JONES & BEACH ENGINEERS INC.

**RE: TAC Response Letter
375 Banfield Road, Portsmouth, NH
Tax Map 266, Lot 7
JBE Project No. 19190.2**

We are in receipt of comments from Stefanie Casella, Town Planner, dated August 2, 2021. Review comments are listed below with our responses in bold.

POTENTIAL LOADING AREA #3

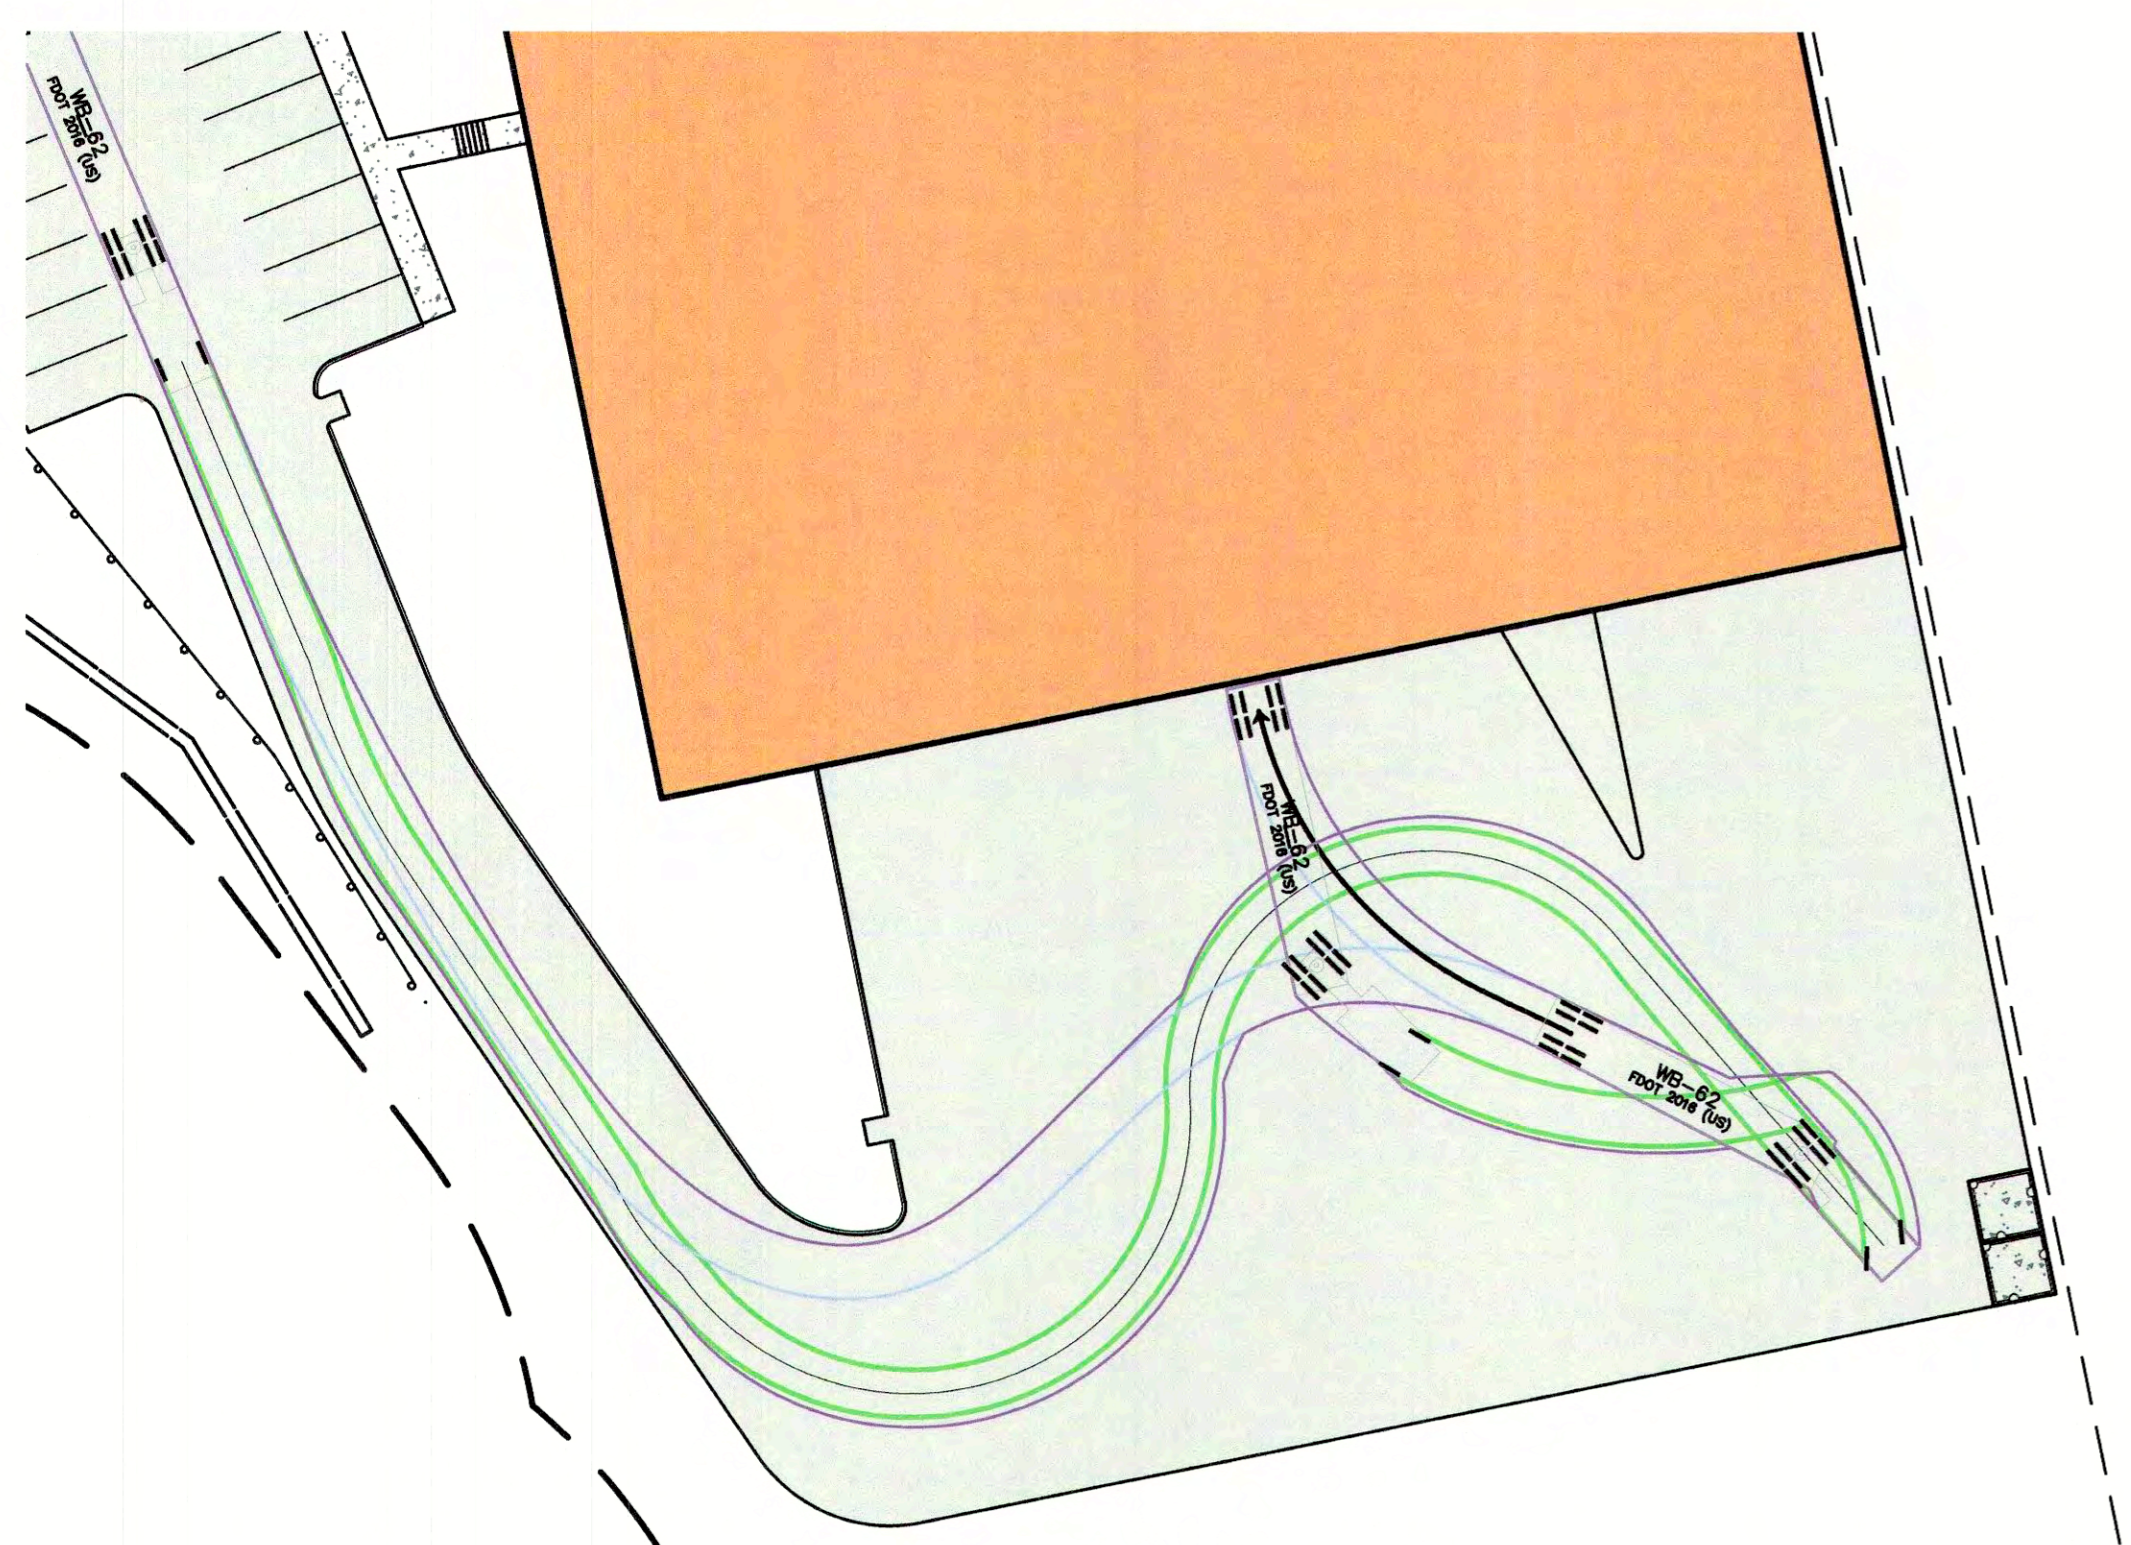
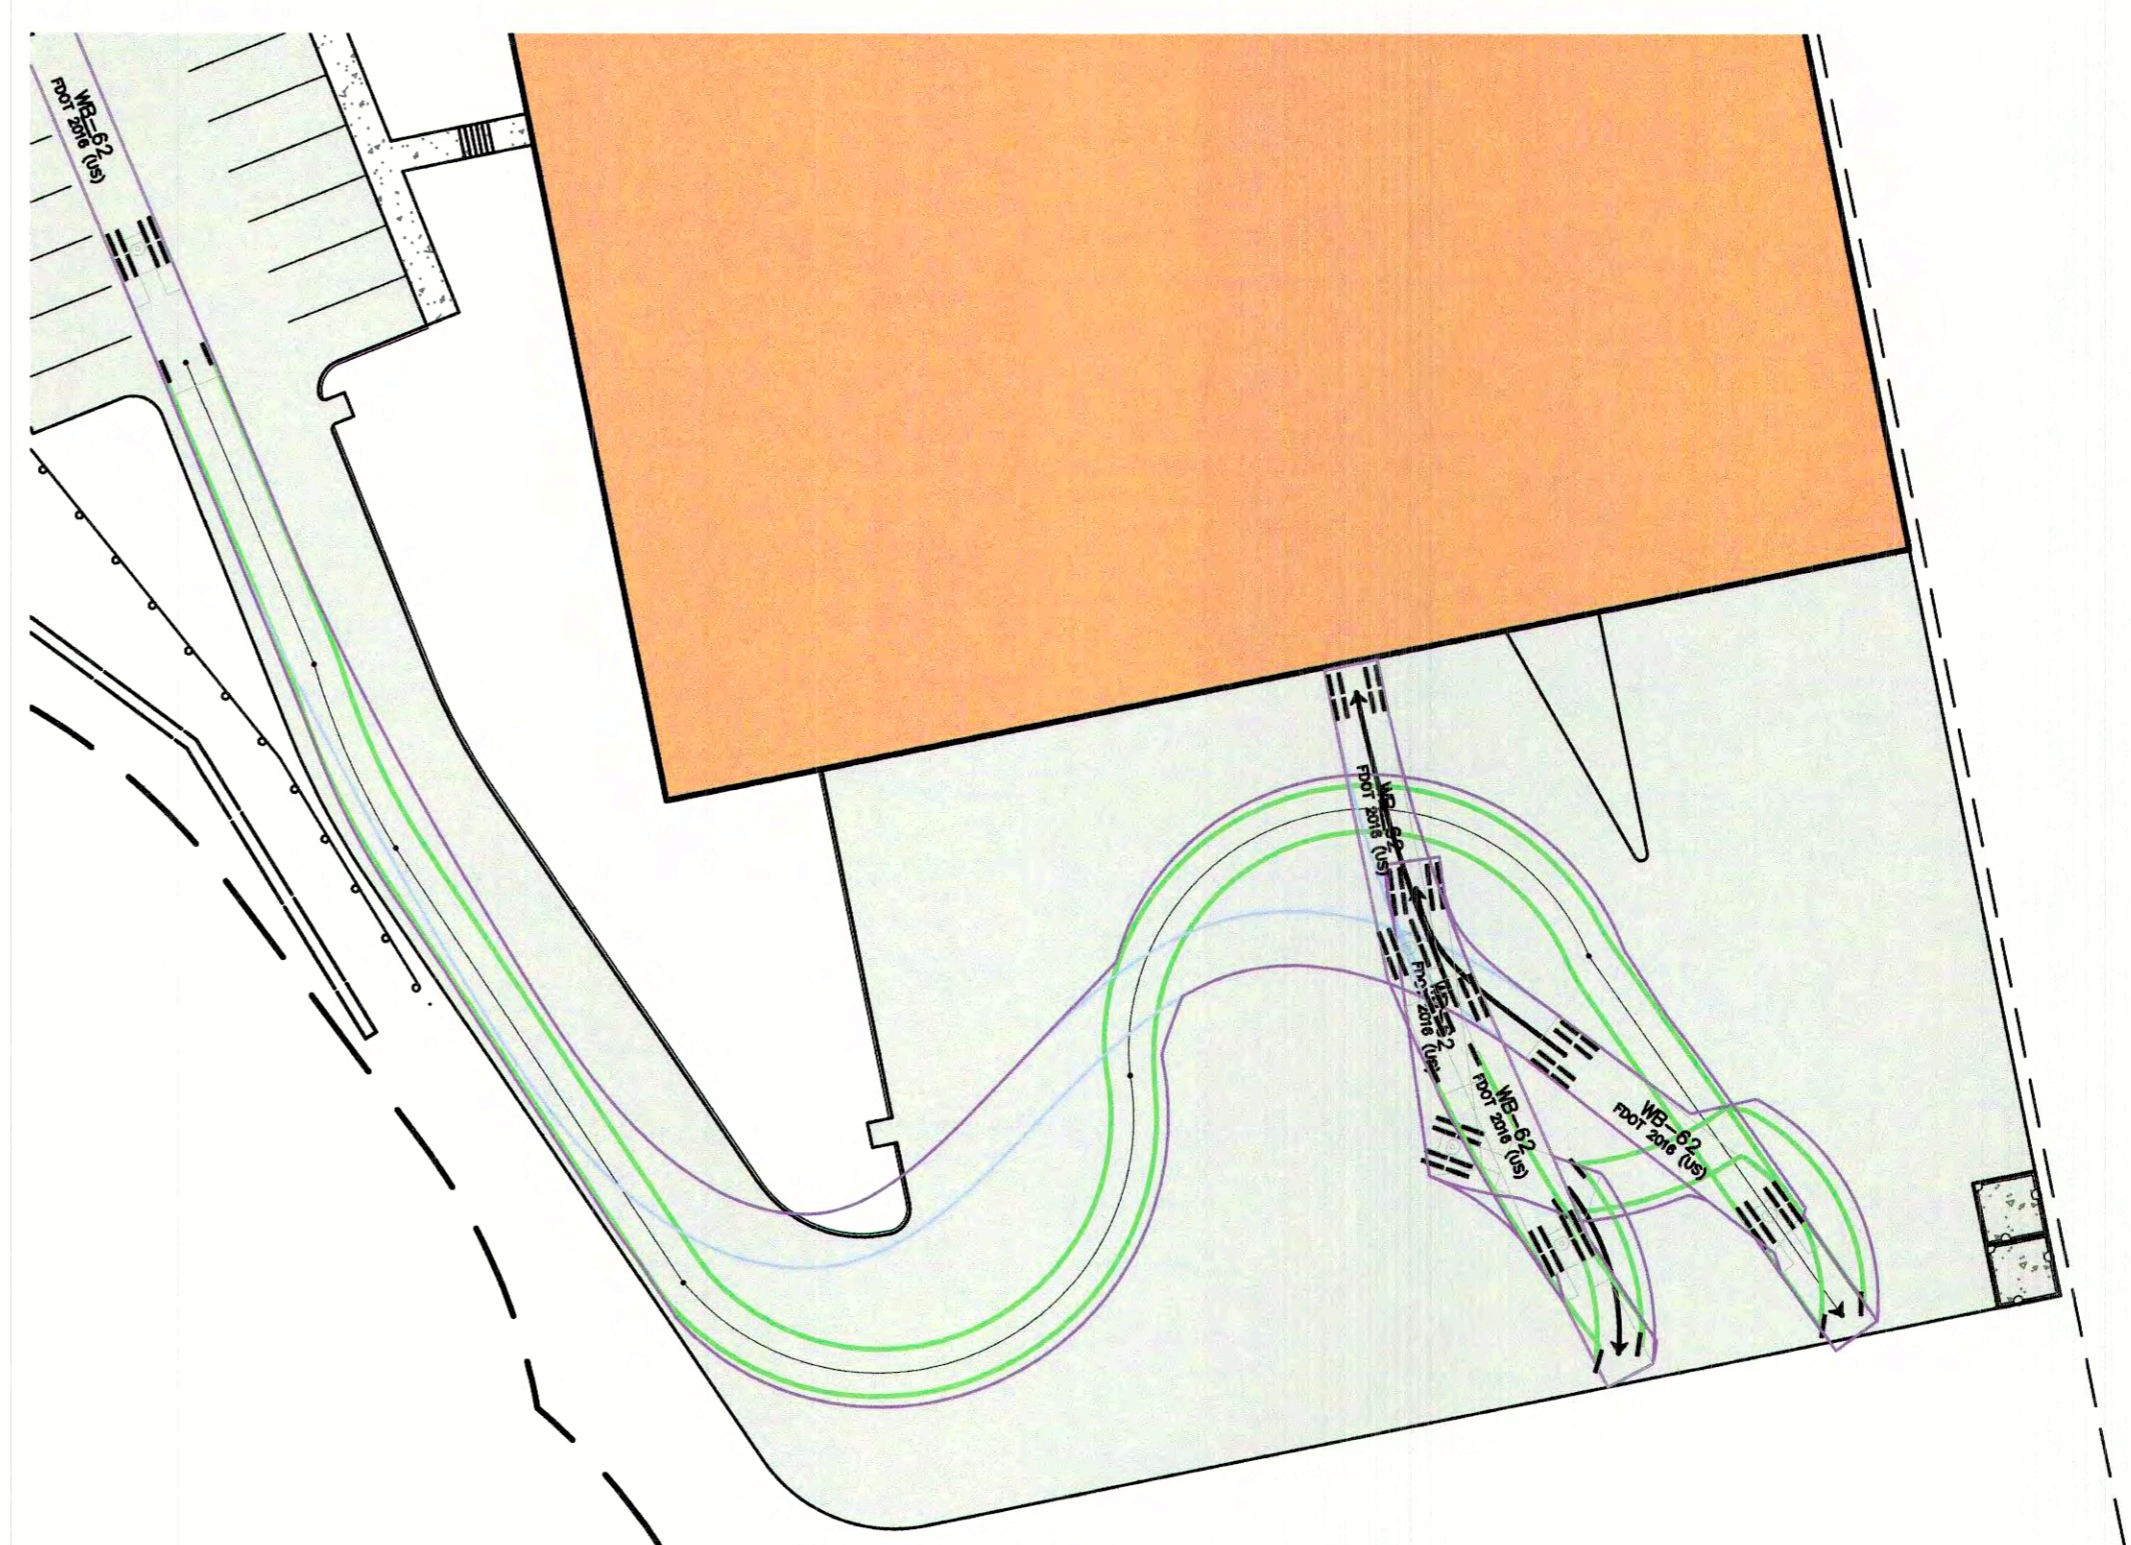
5. *How do trucks navigate the turning movements to all the loading docks?*

RESPONSE: See Sheet T3 with simulations of a WB-62 accessing different loading dock locations.
